## Commercial Pre-Application Meeting

April 14, 2021

2. **South Village PUD (parcel is approx. 1278 acres, located south of SR 44 and west of I-95).** Several inquiries were made by representatives for a potential owner about changing a few aspects of the 2011 PUD in order to design and build a community that would have approximately 1,952 residential units, amenities, and 590, 000 SF for commercial use. An elementary school site is included in the original PUD that requires a separate agreement with the Volusia School Board. There are 3-4 years left on the original agreement for and the decision to not to move forward with a new school.

SOUTH VILLAGE  
PUD SCHEMATIC PLAN

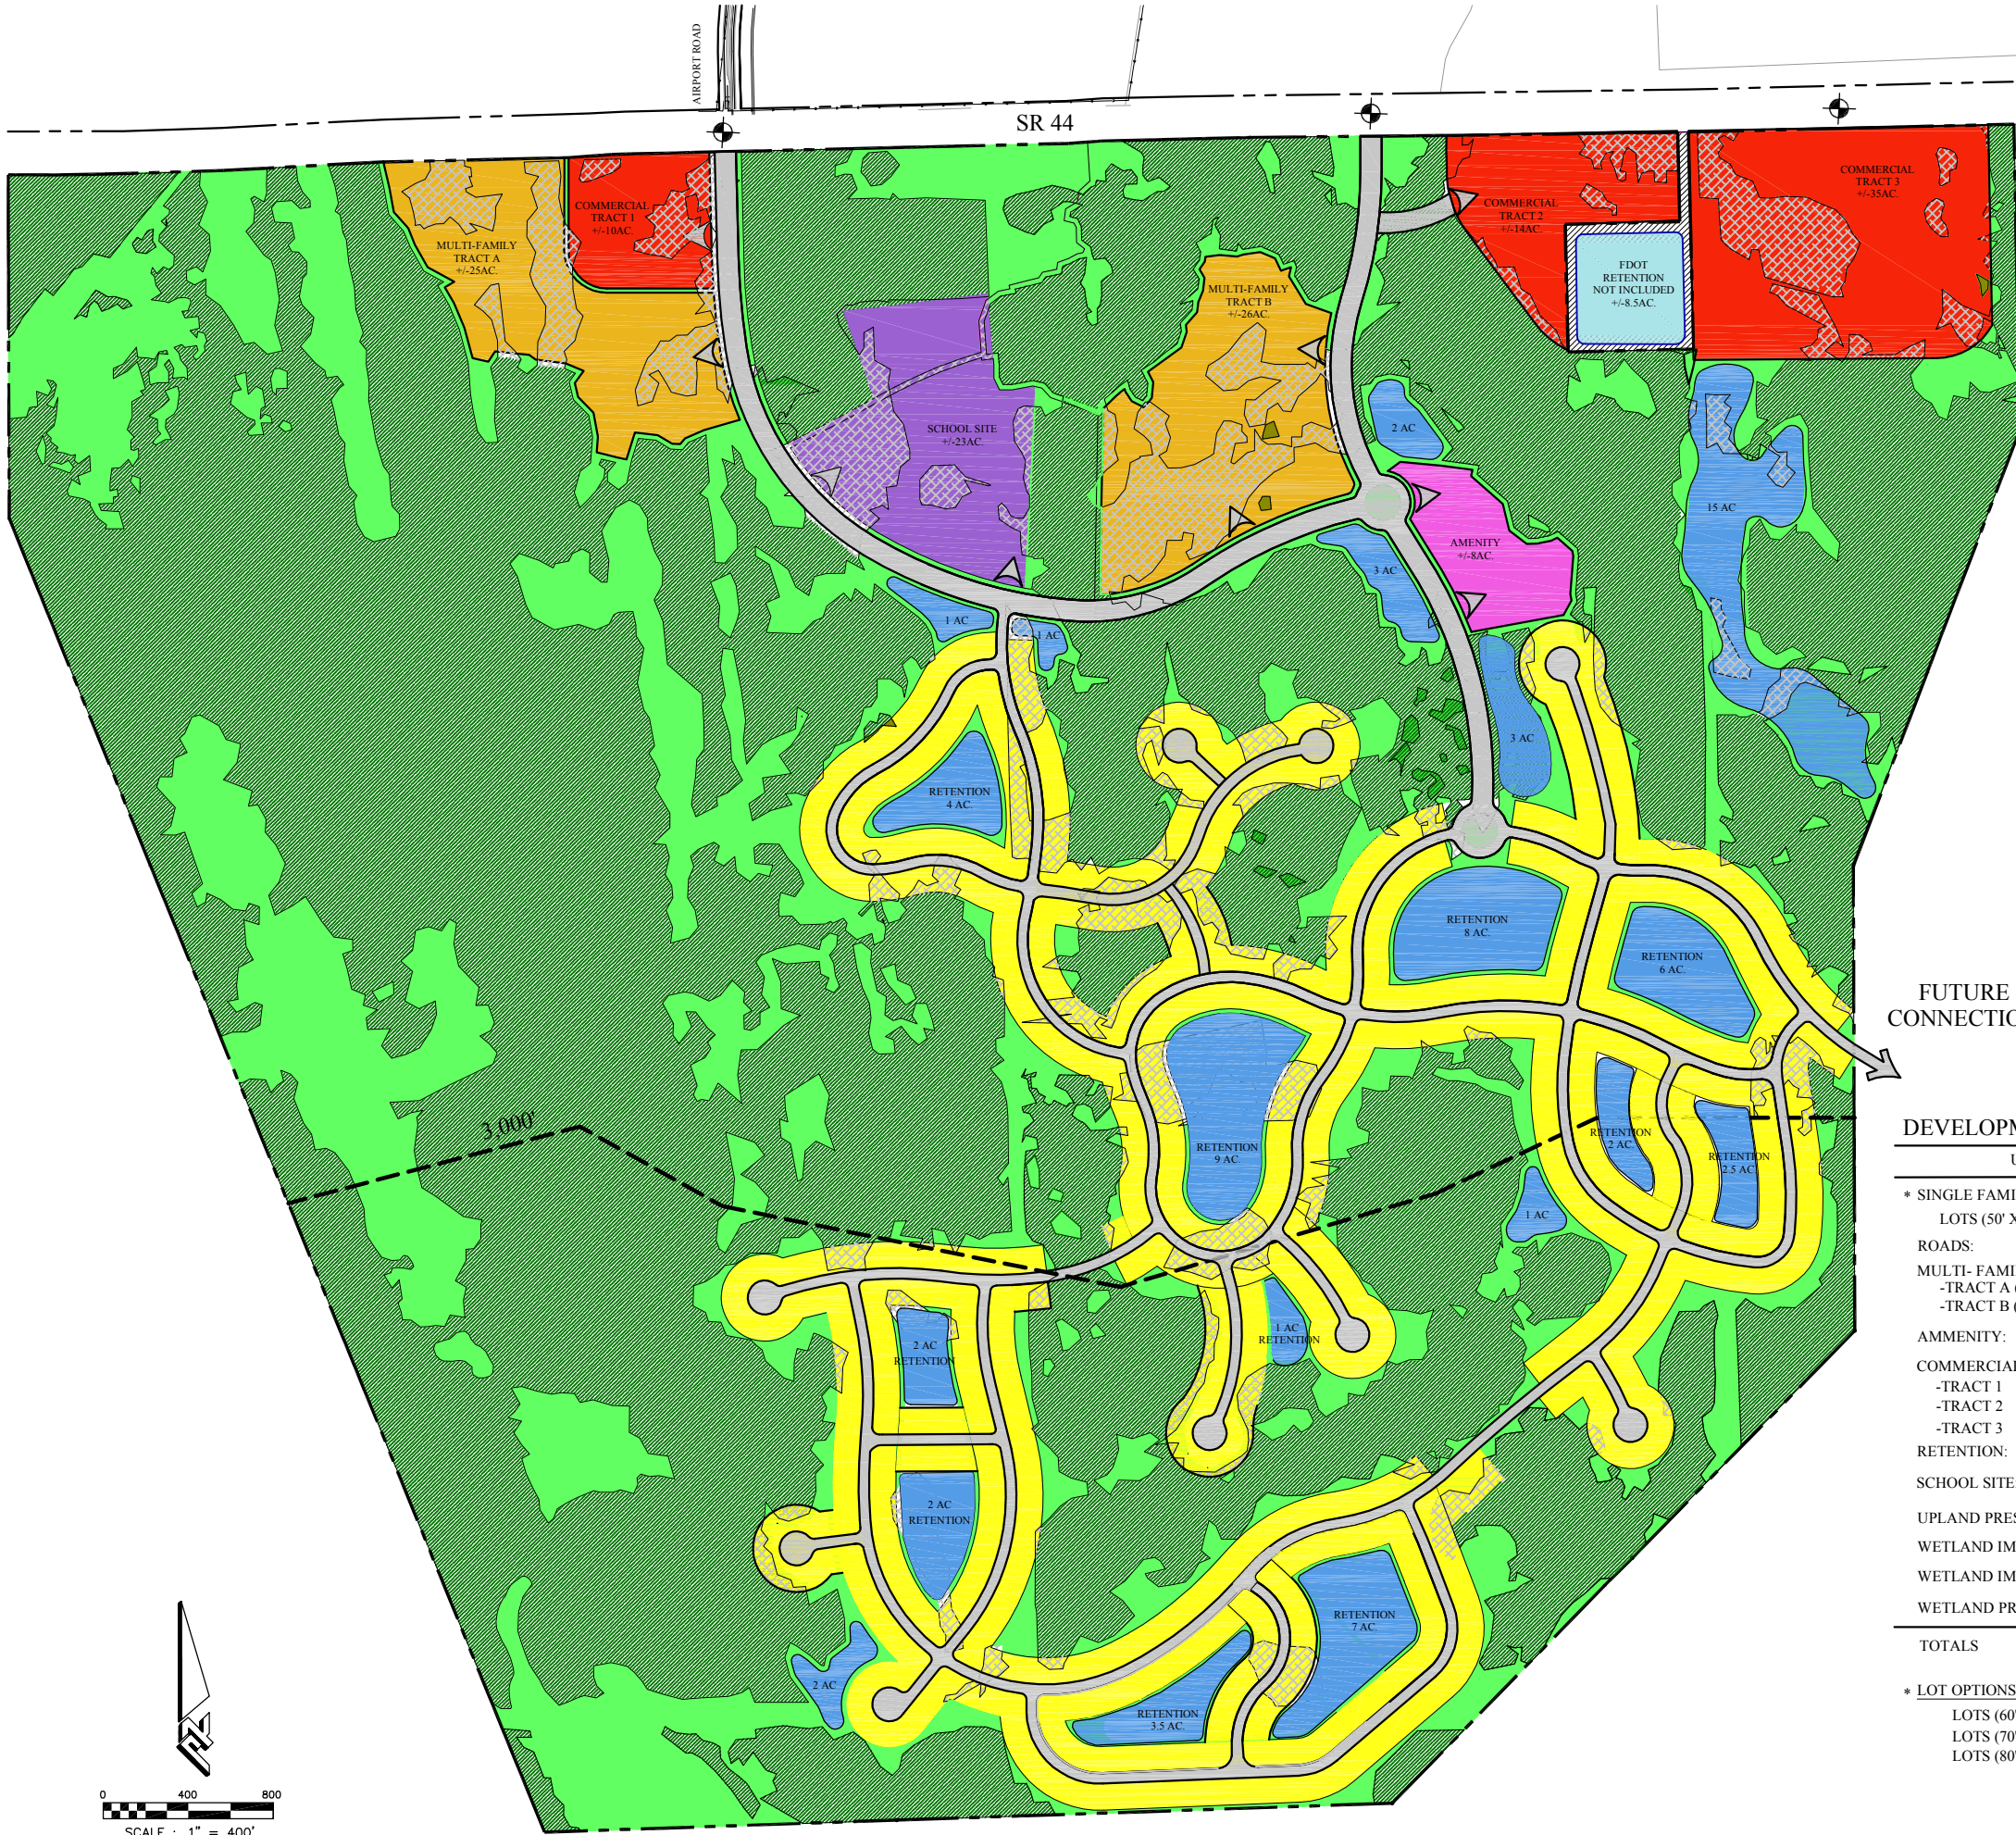
Assistant City Manager, Brian Fields, stated that while a smaller footprint with less wetland impact by staying outside the floodplain is desirable, smaller lots and higher density are a concern. There are problems in new developments with 50'x100' lots regarding setbacks and driveway location/limitations. Also, multifamily development standards differ from single family standards and will need to be followed.

- A master traffic study that identifies the overall traffic demand by phase and at buildout, along with the transportation improvements required and the timing for those improvements must be completed before complete development plans are submitted as traffic is the biggest concern due to the size of the development.

- City Staff questioned the move of the commercial development. It was moved to avoid wetlands, but staff thinks there are wetlands close to SR44 that need to be considered.
- There isn't a collector road system shown. With 1500 single family homes planned on the south side, one is recommended.
- The plan shows that the commercial would be built prior to residential development. City staff stated that often creates built-in nearby opposition or imbalance to the future commercial development.

- No arterial roads make it difficult for UC installation.
- When creating the master utility plan, it is recommended they consult with the Master UC maps for reclaim, water, sewer, etc.
- In the original PUD a water tower was proposed due to water pressure concerns. Size of piping may need to be adjusted.
- Regarding where/when they reserve utility capacity, the UC is separate from the City, but the process goes hand in hand with city approvals; capacity is established when the pre-site plan and phase approval is submitted; a development plan is presented, and a plan rate is based on the number of units in the plan.

- Parking concerns on local roads. Just south of SR 44, impact on current fire rescue system location.
- Would like to see three acres within the South Village to locate a fire station.
